The Town of Hilton Head Island
Design Review Board Regular Meeting
Tuesday, May 14, 2019 – 1:15 p.m.
Benjamin M. Racusin Council Chambers
AGENDA

Town of Hilton Head Island
Minutes of the Design Review Board Meeting
April 23, 2019 at 1:15 p.m.
Benjamin M. Racusin Council Chambers

The Bayshore Phase 2

DESIGN TEAM/DRB COMMENT SHEET

Signage Materials

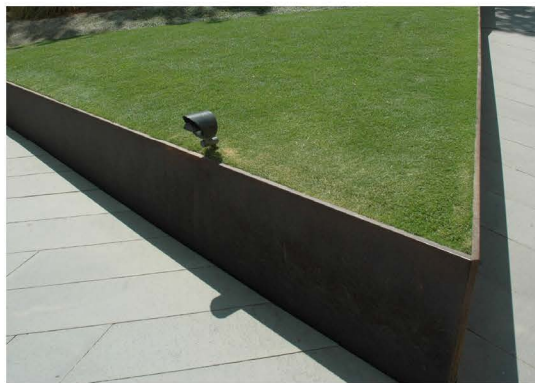
~~Revise the planting plan to include more undulation of the sod edge and reconsider the camellia variety selection to Staff for review and approval.~~ **Staff recommends approval per the 05/03/2019 revised Planting Plan.**

LANDSCAPE DESIGN				
DESIGN GUIDE/LMO CRITERIA	Complies Yes	No	Not Applicable	Comments or Conditions
Shrubs are selected to complement the natural setting, provide visual interest and screen less desirable elements of the project	<input type="checkbox"/>	<input checked="" type="checkbox"/>	<input type="checkbox"/>	The proposed variety of camellia is upright. Reconsider the variety selected to be planted along the sod edge for one that is more spreading or mounding. Done 05/03/2019
Large grassed lawn areas encompassing a major portion of the site are avoided	<input type="checkbox"/>	<input checked="" type="checkbox"/>	<input type="checkbox"/>	Sod edge should undulate more and not reflect the road edge. Done 05/03/2019

MASS SCHOOLS
SOUTH BRITAIN
ST FRANCIS BY THE SEA
CATHOLIC CHURCH

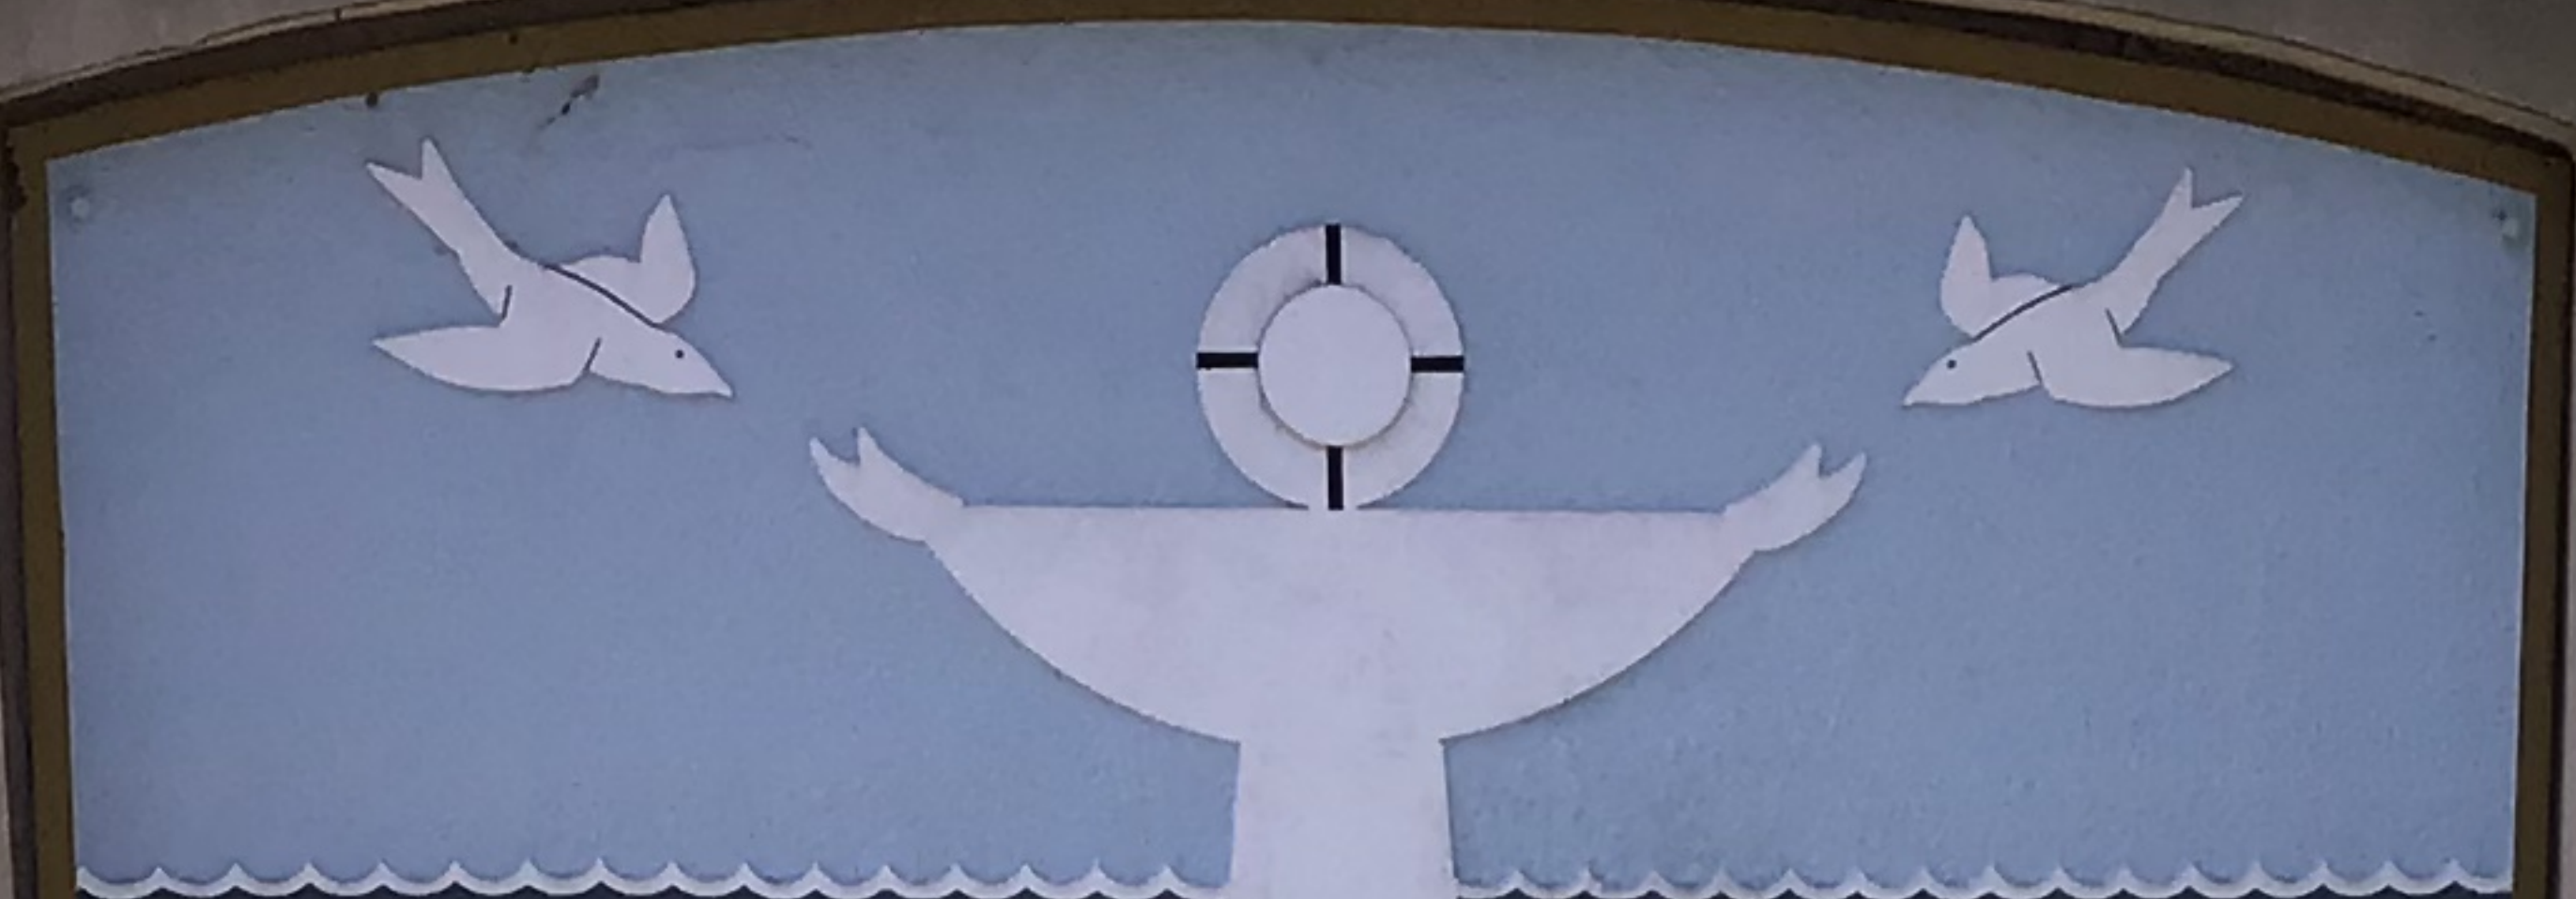
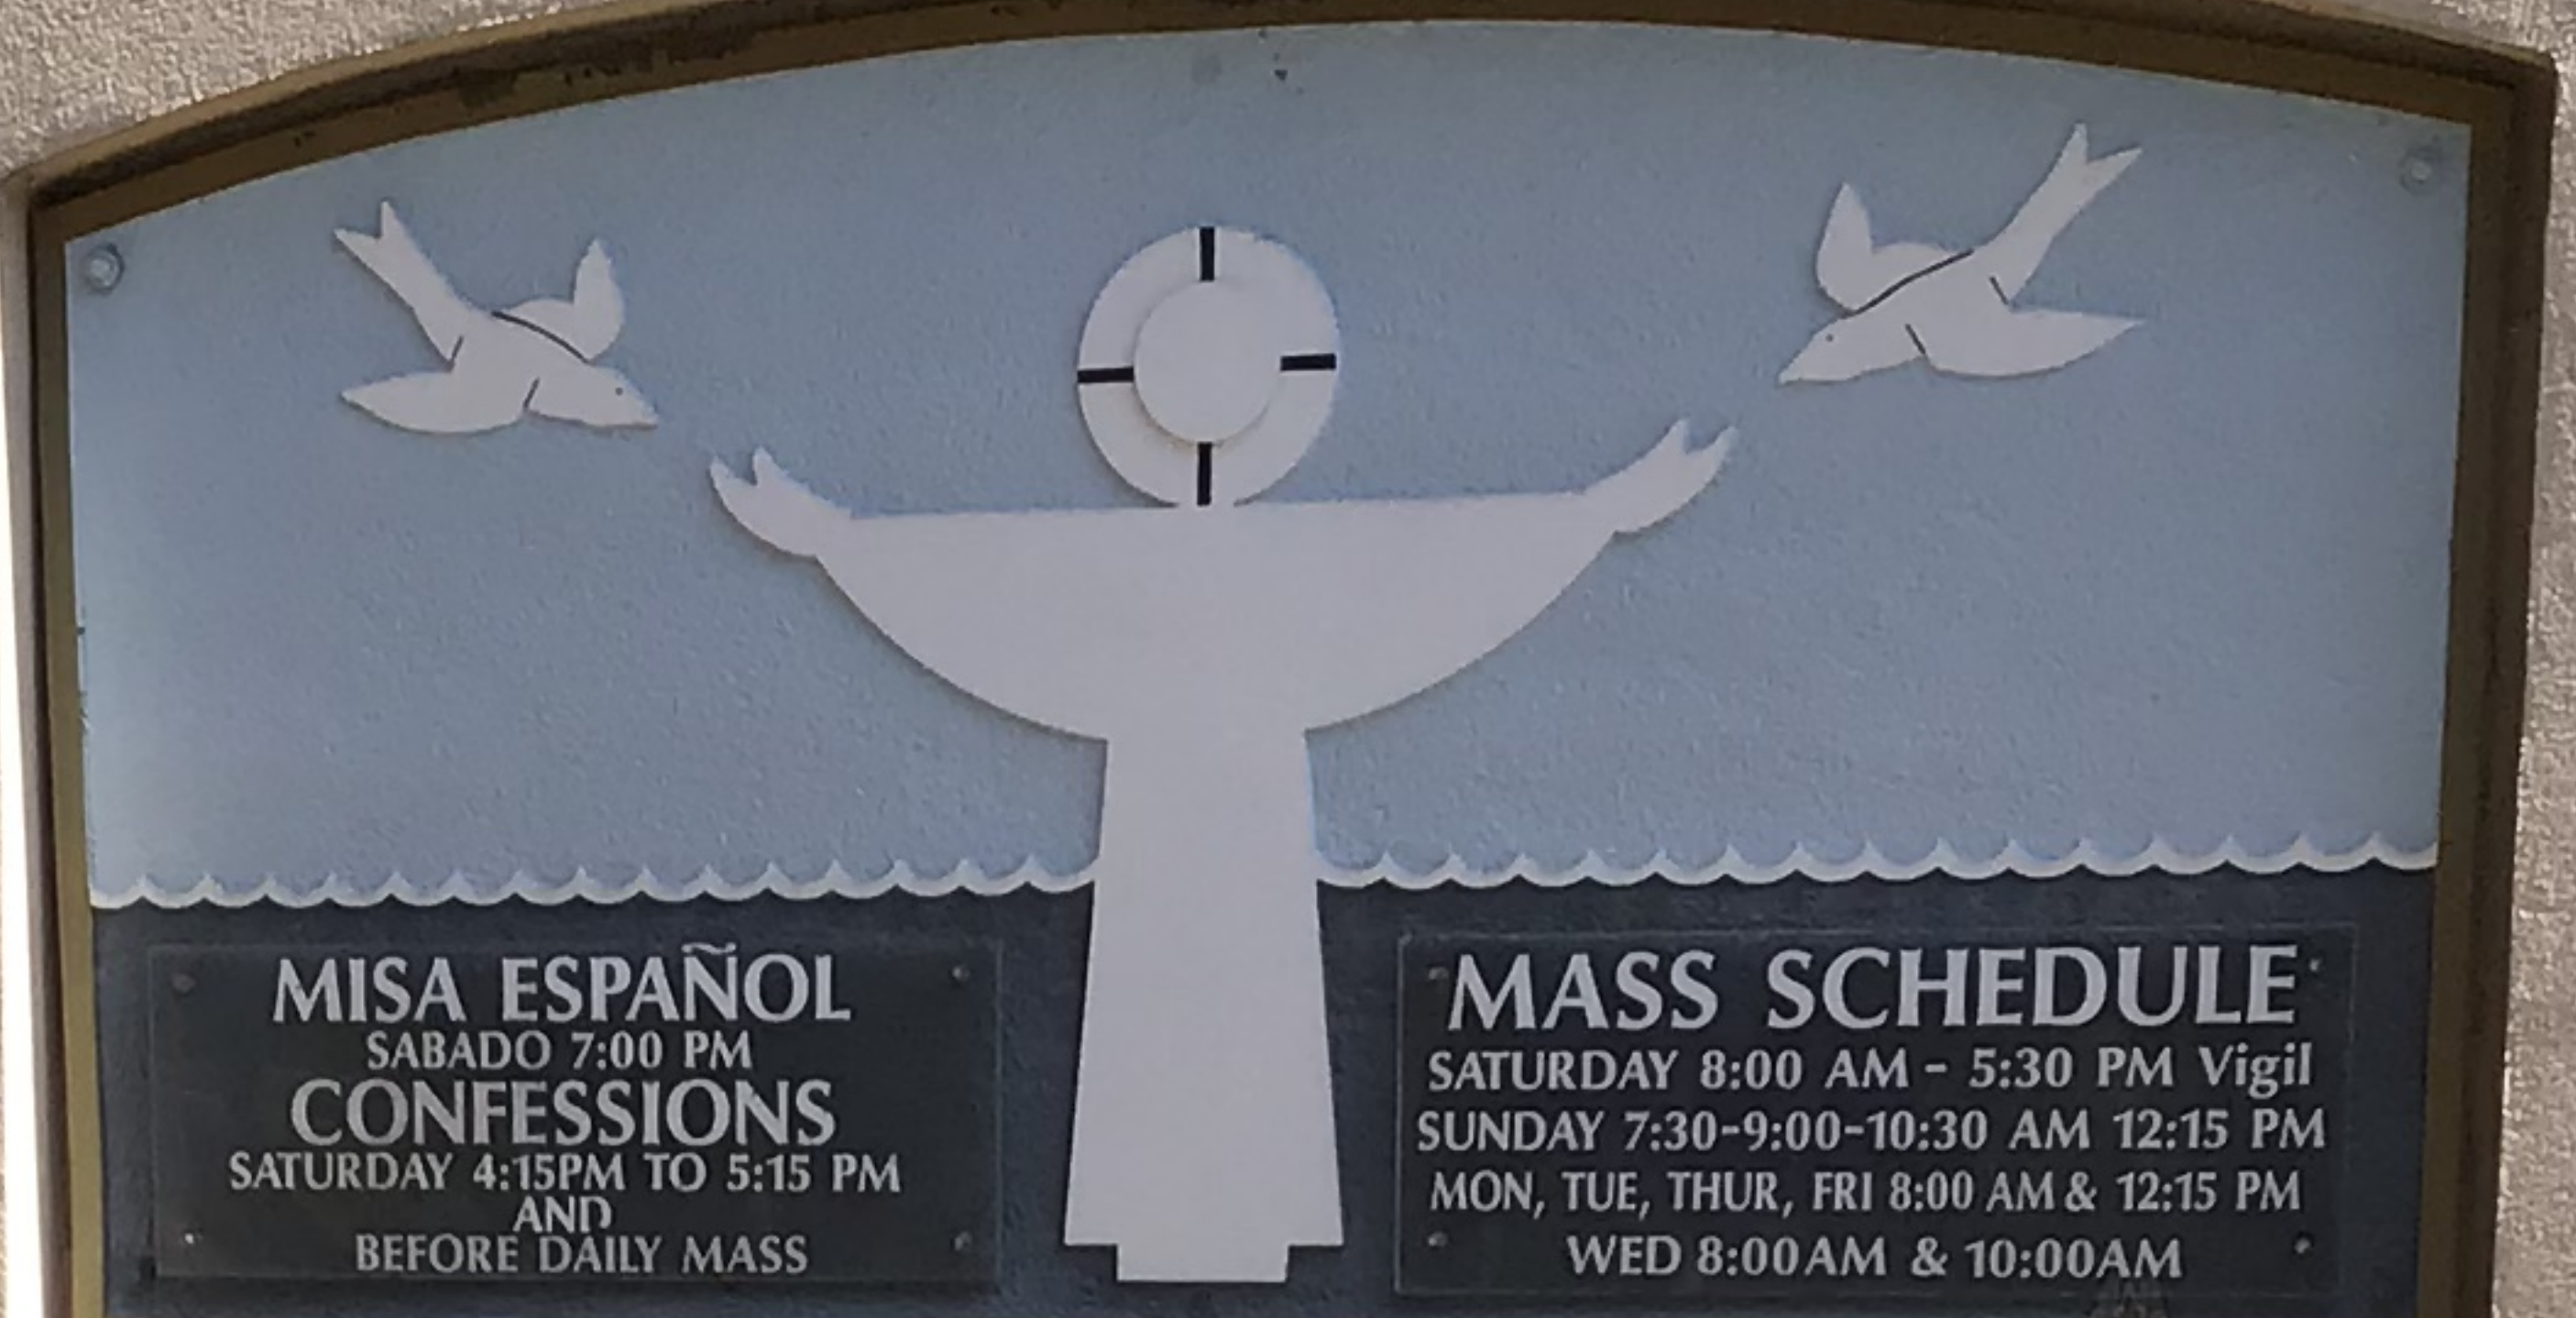
- ~~1. Provide the overall height of the existing sign for comparison to the proposed sign height.~~
2. Provide a narrative for this project. Include: the sign location (replacing the existing) and that the sign is double sided (if it is).

RENDERING – MATERIALS				
REQUIRED INFORMATION & DESIGN STANDARDS	Yes	No	N/A	Comments & Questions
If they will be used, existing structure or posts are clearly visible in photos.			X	It appears the existing sign will be removed and replaced with the proposed in the same location.
Structure or post materials are listed, e.g. “Concrete block with stucco”, “4 inch x 4 inch wood posts”.		X		Please reference structure construction in narrative.
Sign panel materials are listed, e.g. “2 inch thick HDU”.		X		<ol style="list-style-type: none"> 1. What are the letters? Are they applied? Are the letters 1” deep? 2. What color is the brick? Will it match the building brick?
All materials match the Town-approved sign system, if applicable.

RENDERING – DIMENSIONS				
REQUIRED INFORMATION & DESIGN STANDARDS	Yes	No	N/A	Comments & Questions
The sign does not exceed the size limit in LMO Section 16-5-114.F.				
Logo dimensions, if applicable.		X		Provide a dimension for the logo.

RENDERING – DESIGN				
REQUIRED INFORMATION & DESIGN STANDARDS	Yes	No	N/A	Comments & Questions
The street address of the site is shown in 4 inch tall numbers on both sides of the sign. Note: The street name may be also required if the site accesses more than one street.		X

RENDERING – COLORS				
REQUIRED INFORMATION & DESIGN STANDARDS	Yes	No	N/A	Comments & Questions
Colors reflect/complement the colors on the building walls, trim, etc.		X		
Background colors are earth tones: green, brown, beige, and grey.		X		Consider a dark background with light lettering (example: bronze background with Navajo White letters).
Subdued shades of color are used.		X		Staff will not recommend approval of Navajo White for the background of a sign this large.

LIGHTING				
REQUIRED INFORMATION & DESIGN STANDARDS	Yes	No	N/A	Comments & Questions
For new signs or signs without existing lighting, rendering states: "New lighting will be installed" or "The sign will not be illuminated."		X		Please add note to the drawings.

LANDSCAPE PLAN				
REQUIRED INFORMATION & DESIGN STANDARDS	Yes	No	N/A	Comments & Questions
The proposed landscaping matches or complements the existing vegetation on site.		X		<ol style="list-style-type: none"> 1. The proposed landscape does not match or complement the existing landscape. Include the massing of the existing landscape so it is illustrated how the new landscape blends with the existing. 2. Ligustrum is an exotic invasive species and should not be used. 3. Planters are discouraged because they are often not properly maintained. Annual color can be provided in beds at the base of the sign with an evergreen groundcover as a backdrop or frame between the annual bed and sign.
